**Supplement
to the Montague Wind Power
Facility Application for
Site Certificate**

Prepared for
Oregon Department of Energy

March 2015

Figure C-6

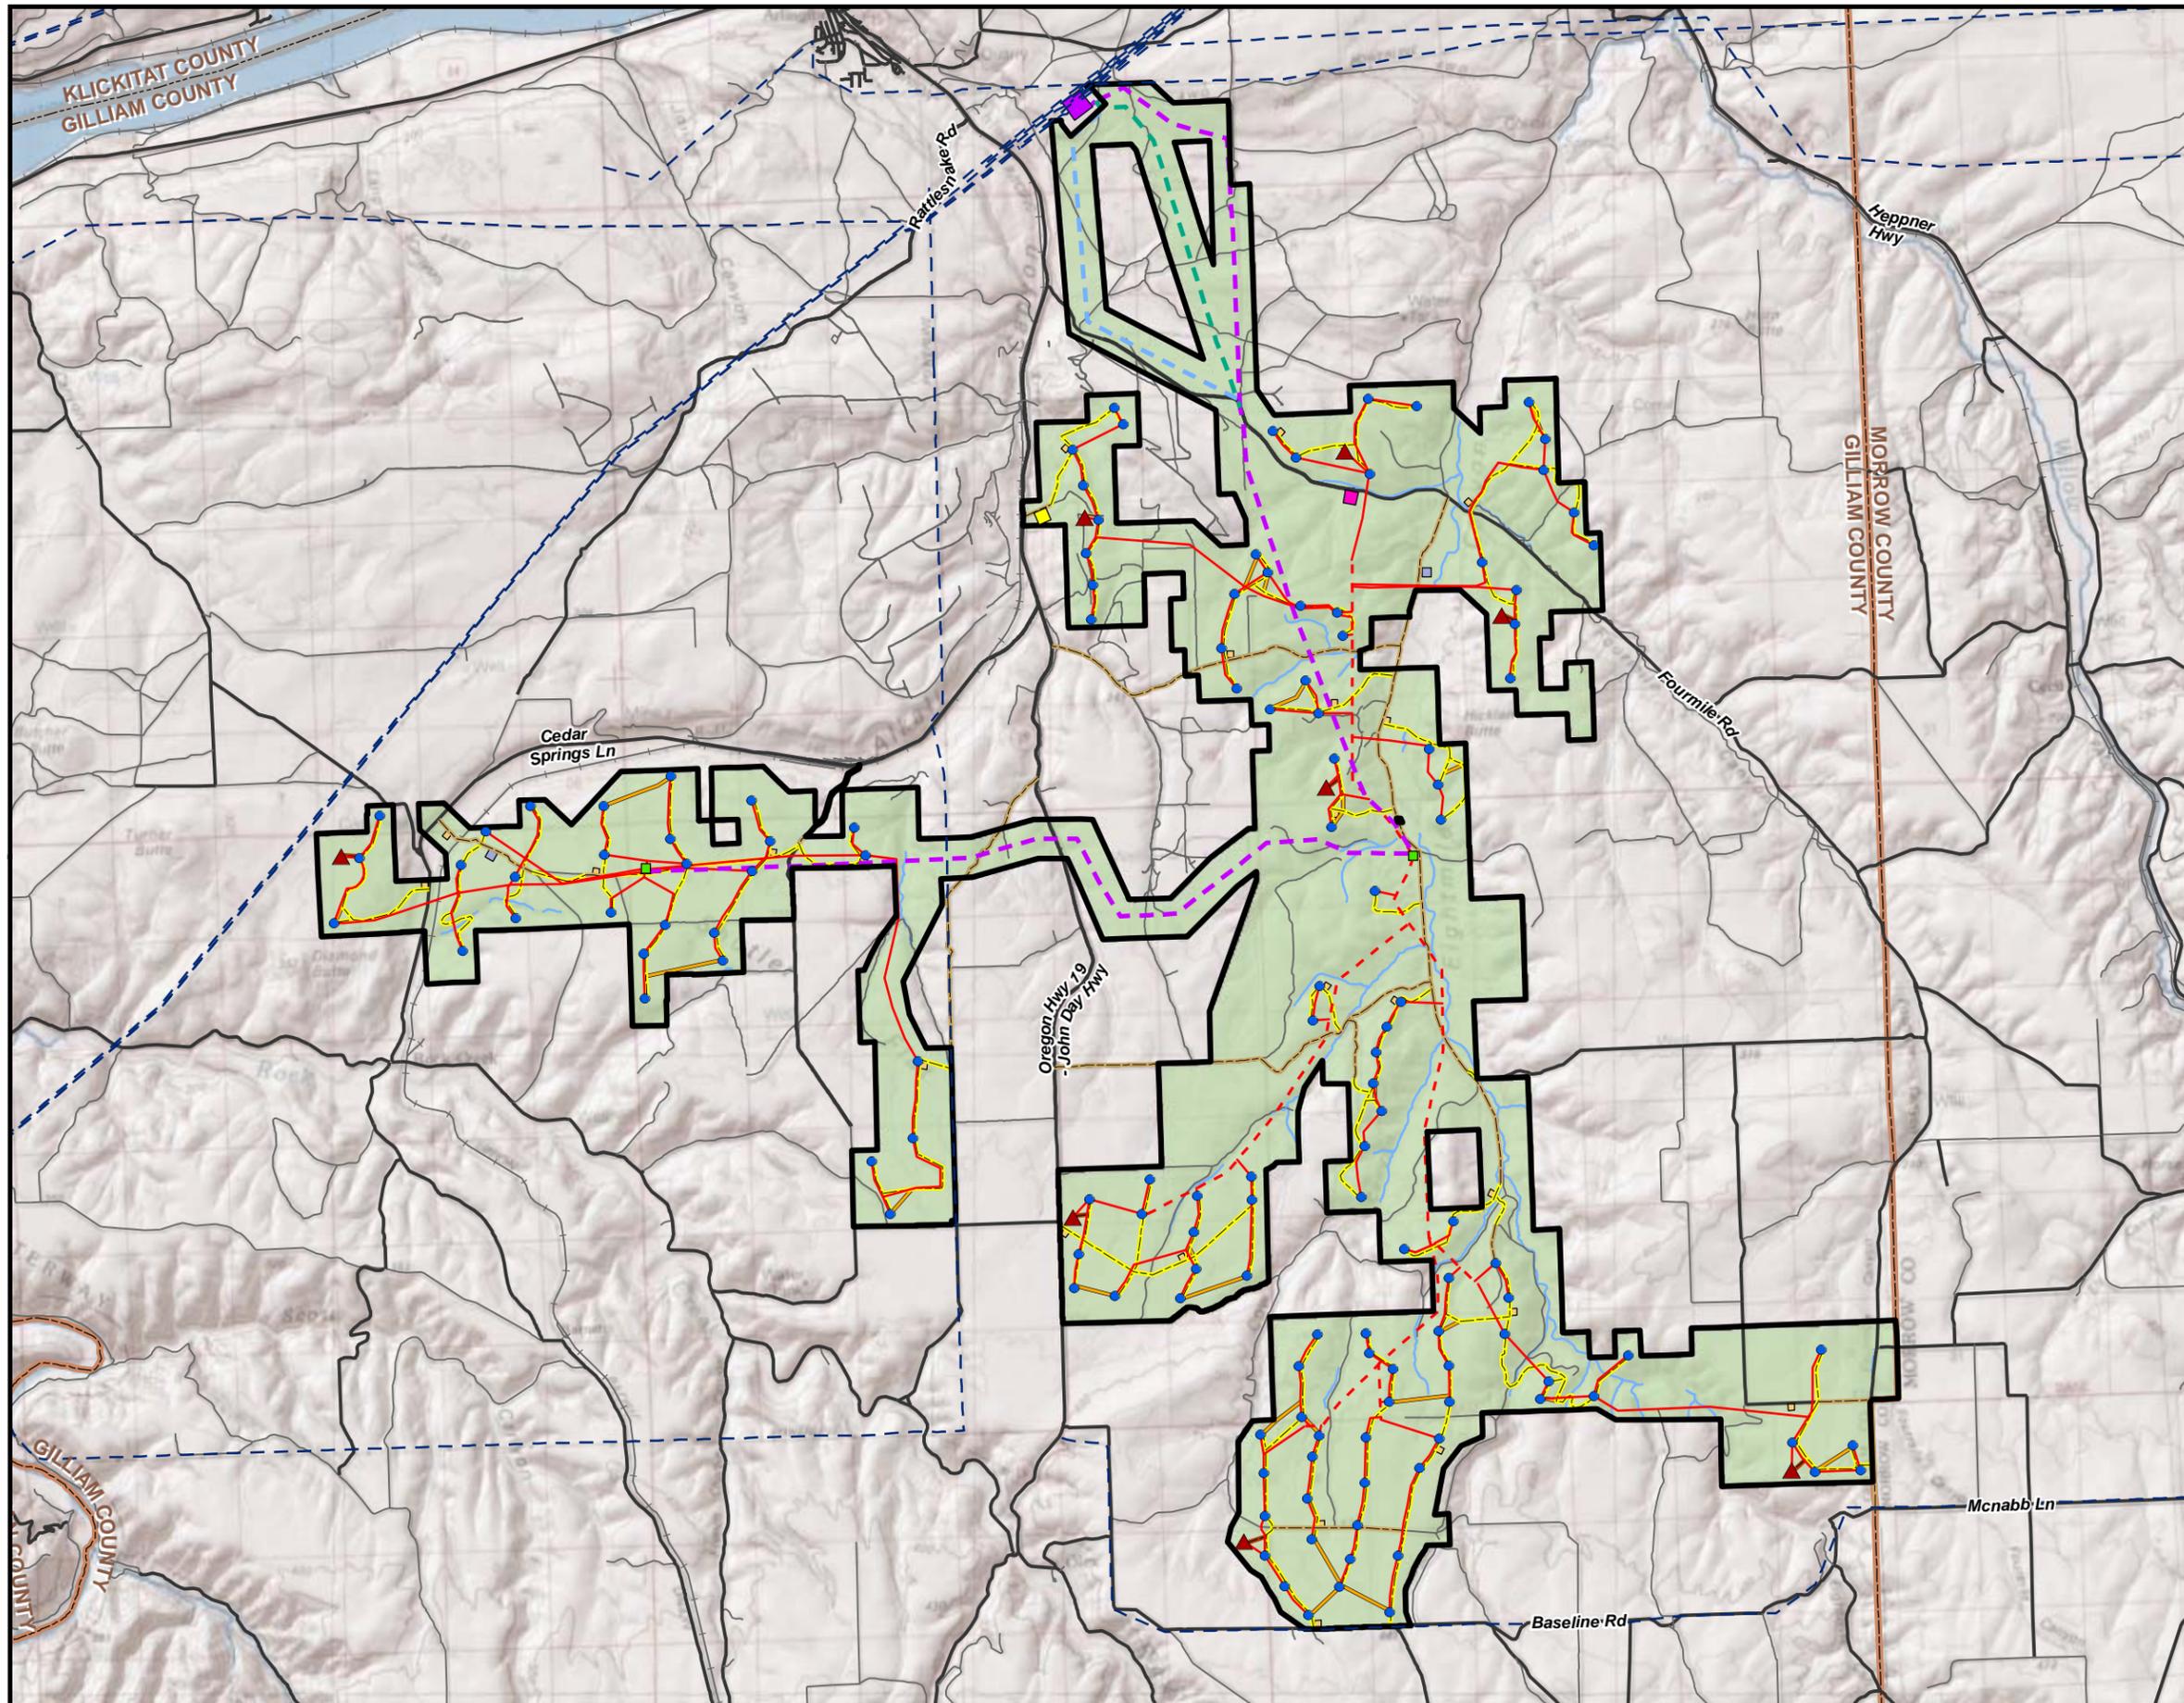
Figures C-6 and C-7: Discussed at the meeting on 2/25. The maps are missing collector lines, access roads and staging areas for the 3.0-MW layout. IBR noted that the 3.0-MW layout provided in the LJII Request for Amendment #1 also did not show these components. We requested updated Figures C-6 and C-7.

Response e-mailed to John White/ODOE and Kara Warner/Golder on March 5, 2010, with updated Figures C-6 and C-7 (see Attachment C-1).

Figure C-7a
Facility Components -
Detailed View 1 of 4
 3.0-MW Turbine Layout
 (Minimum Turbine Layout)
 Montague Wind Power Facility

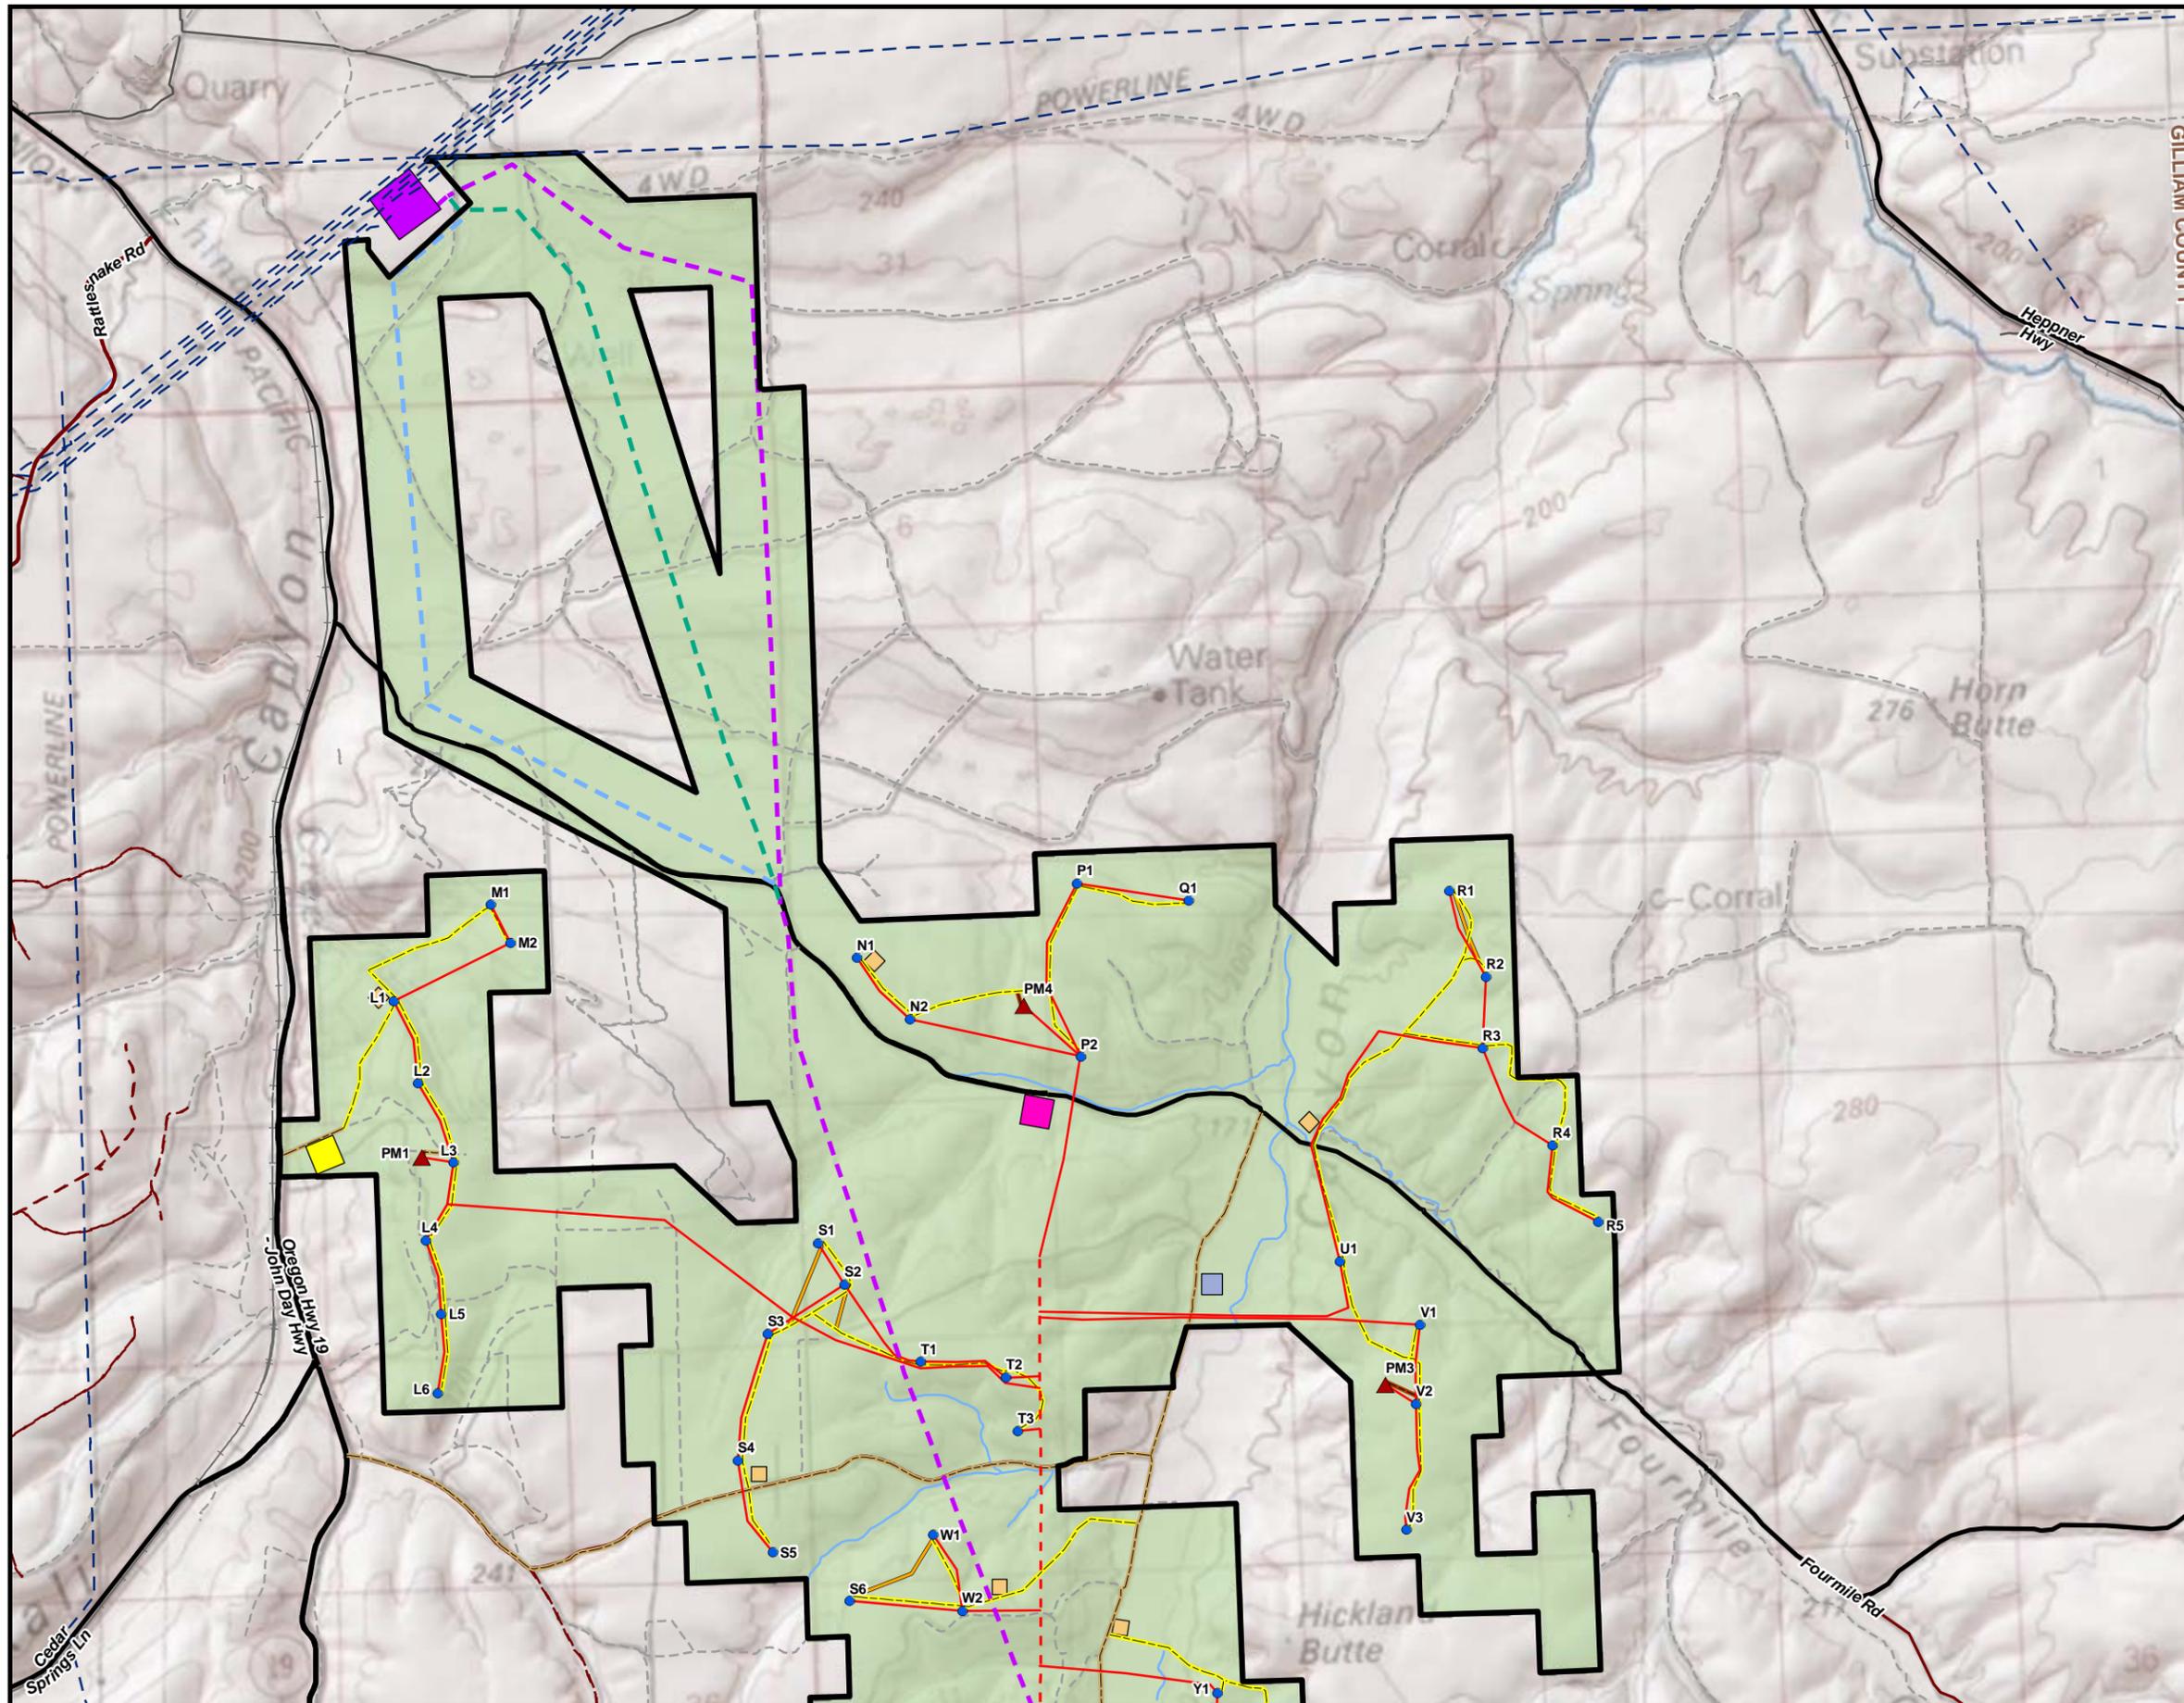
The Department compared the photo-simulation of the MWPF turbines with the proposed facility layouts (Figures C-5c and revised Figure C-7a) to determine which turbines are visible in the photo-simulations. It appears to us that the turbines shown in the photo-simulation of the 1.5-MW turbines are turbines in the V-string. We note that met tower PM3 is adjacent to this string, and we would be concerned about it being visible from the Fourmile site as well. We are uncertain what turbines are shown in the photo-simulation of the 3.0-MW turbines. Parts of five turbines are shown in the simulation, but there are only three turbines in the V-string shown in the 3.0-MW layout (revised Figure C-7a). Met tower PM3 is also part of the 3.0-MW layout.
